Parkhill

PROJECT NO.: 03.9006.20 1/11/2022 DATE: January 11, 2022	ADDENDUM NO: 004	Permian Basin (and Economic I Building - Midla	ALL PLANHOLDERS Parkhill E: University of Texas UTPB) Center for Energy Diversification (CEED) nd Campus & Dunagan s Building on the Odessa B	Contraction of the second seco
DATE: January 11, 2022		PROJECT NO.:	03.9006.20	1/11/2022
		DATE:	January 11, 2022

This Addendum consists of 2 pages and the attachments: Project Manual: Section 00 42 00 Proposal Form, Section 01 23 00 Alternates. CEED Building Drawings: Sheet A-111 – ANNOTATED/DIMENSIONAL FLOOR PLAN- AREA A, Sheet A-131 – REFLECTED CEILING PLAN – AREA A, Sheet A132– REFLECTED CEILING PLAN-AREA B, Sheet I-121 – WALL FINISH PLAN – AREA A Appendix: RFI Responses

WALL FINISH LEGEND

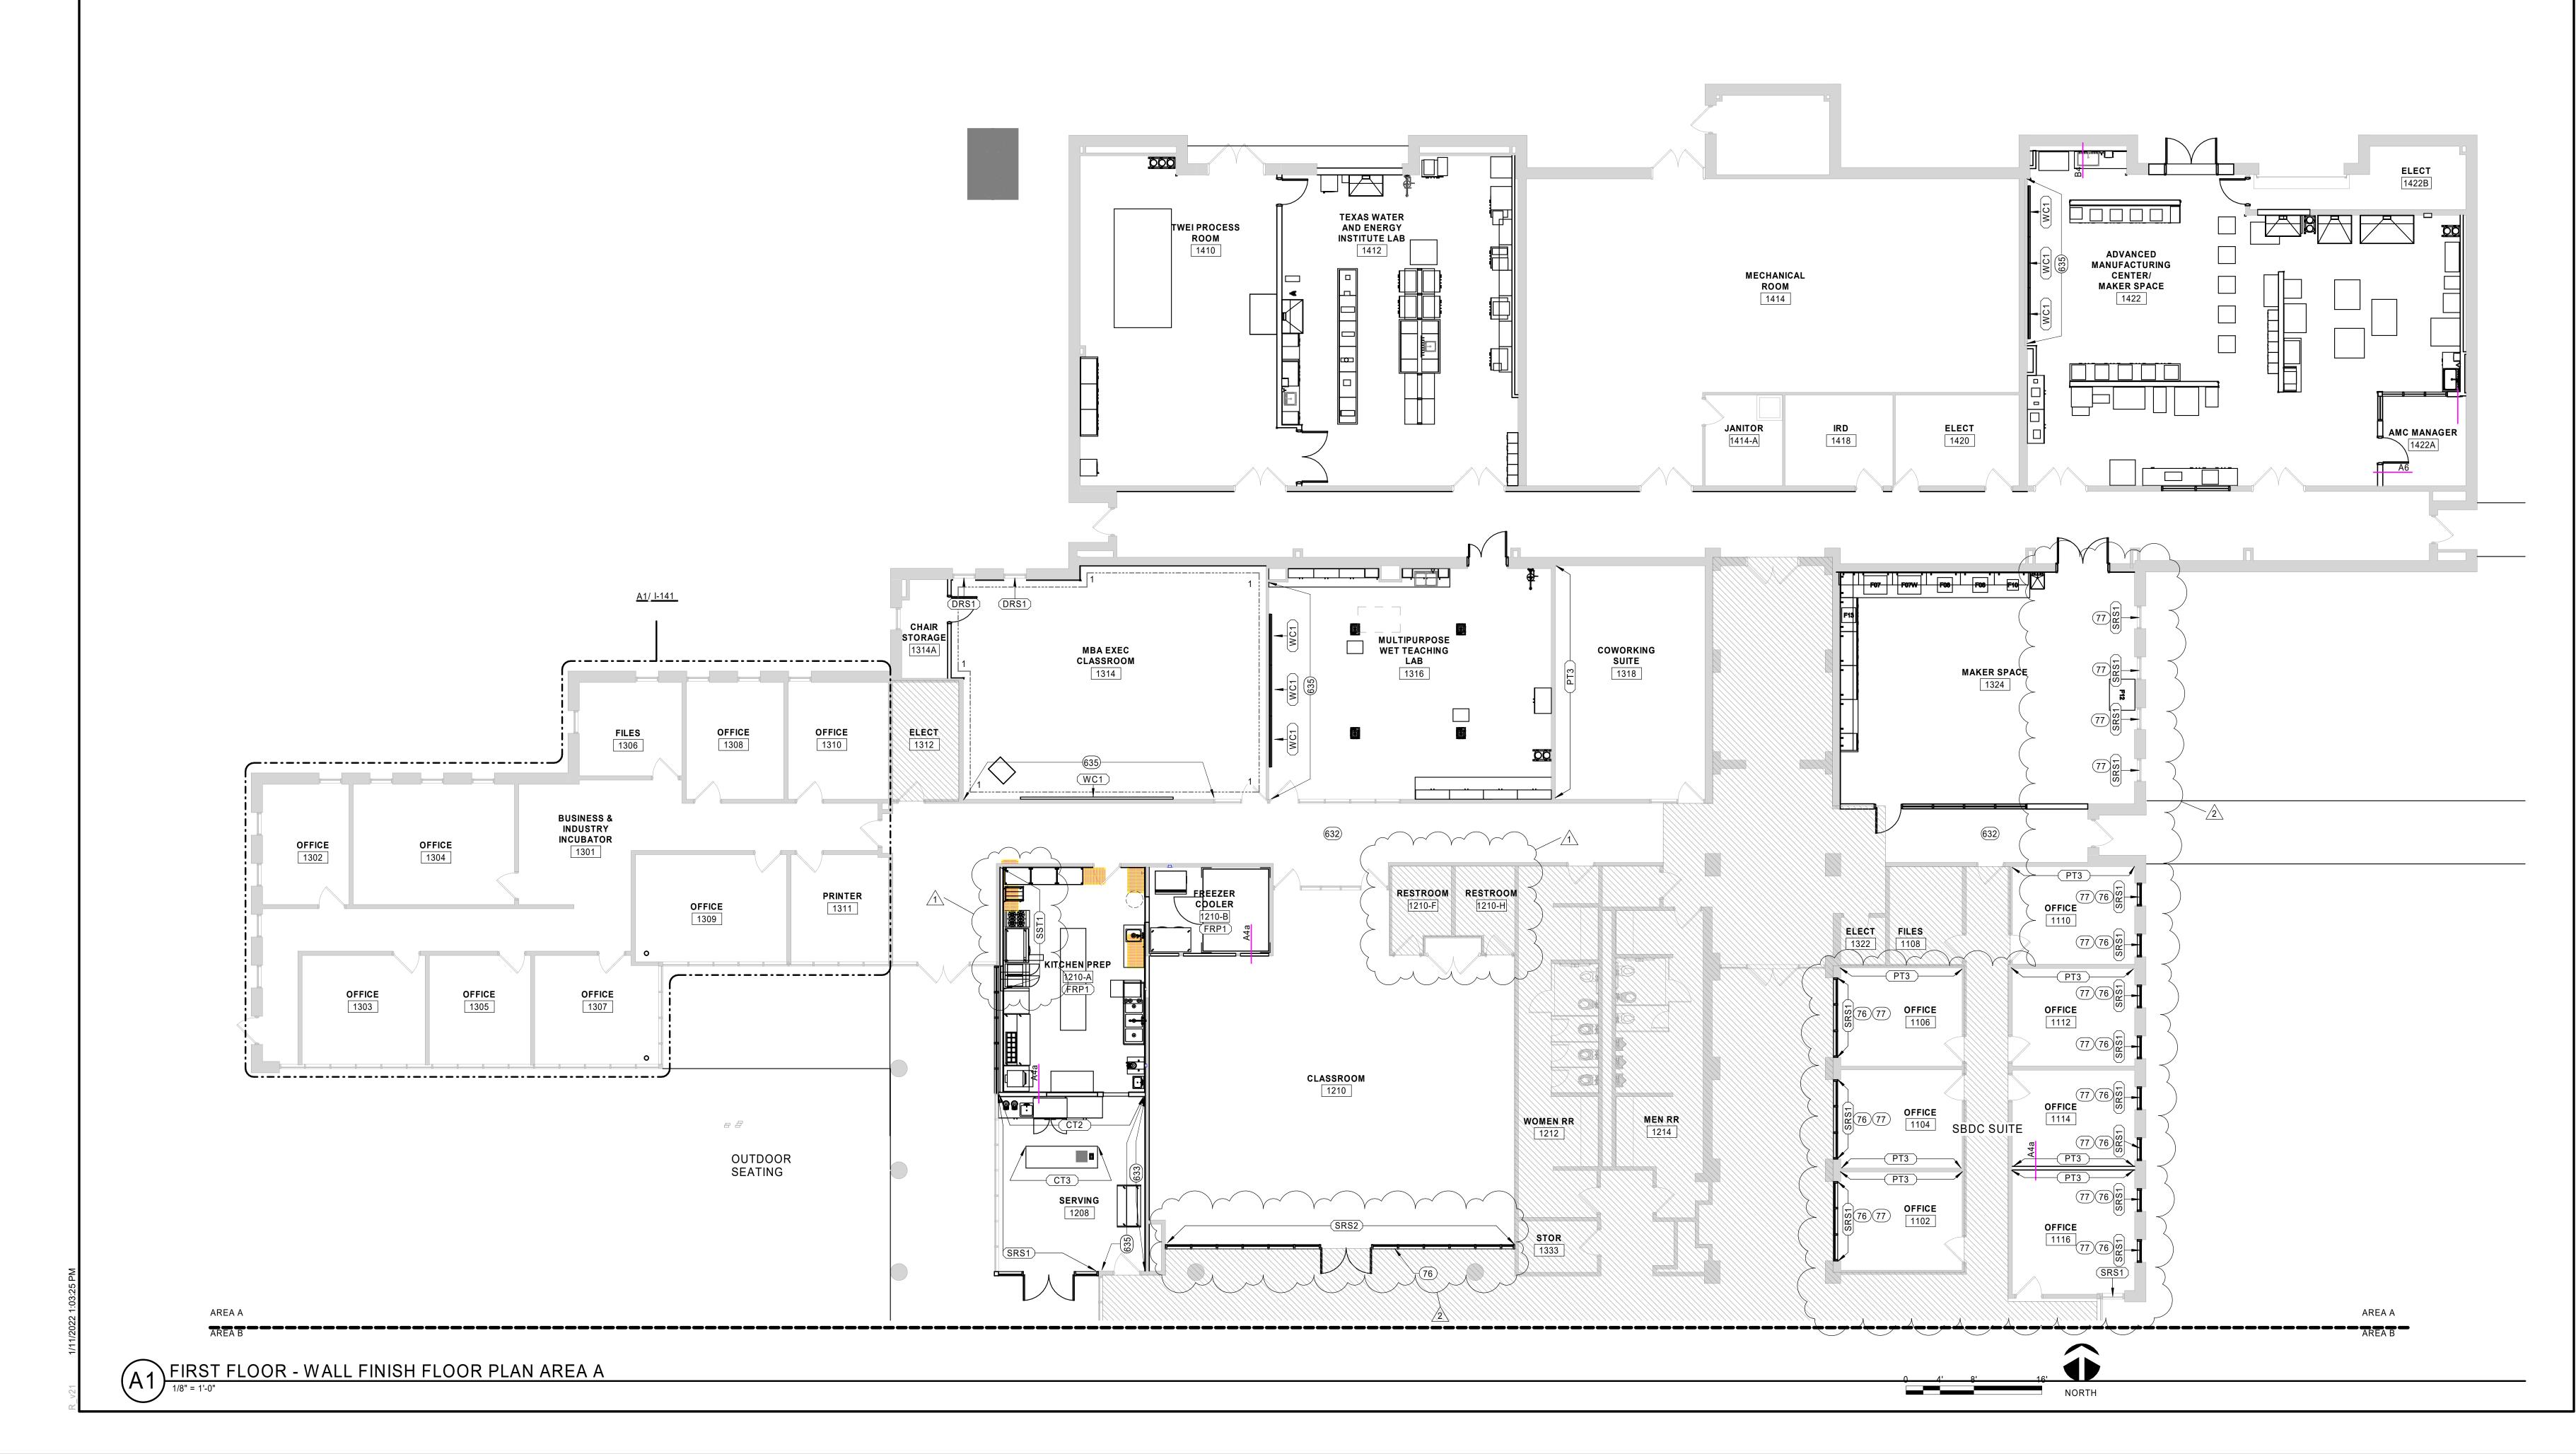
- 1) Clarify Alternate 2 locations updated and clarified
- 2) Revised keynotes 76 and 77
- 9. Sheet E-121 POWER PLAN AREA A
 - a. Change note 4 to read "AS PART OF ALTERNATE 2b, PROVIDE JUNCTION BOX FOR POWER TO MOTORIZED SHADES. COORDINATE EXACT LOCATION OF POWER SUPPLY AND POWER REQUIREMENTS WITH MOTORIZED SHADES PROVIDER"
- III. APPENDIX
 - 1. RFI Responses
 - a. The attached document details questions and answers in reference to this Addendum 004.
 - b. This document begins numbering at #36. Previous questions and responses were addressed in Addendum 003 and distributed by UTPB.

39) Request: Page A-111 note 76 of the CEED drawings calls for electrostatic glazing for alternate 02A at both classroom 1210 and SBDC suite 1101A, but pages I-111 and I-121 note 8 only shows the electrostatic glazing at classroom 1210. Can you verify if the electrostatic glazing will go in only at classroom 1210, or in both locations. Are there any elevations showing the pane design layouts, sizes, and quantities to help with cost estimation?

Response: Yes, electrostatic glazing will go in both locations, refer to Addendum #4. The electrostatic panels will go up to 9'-0" AFF
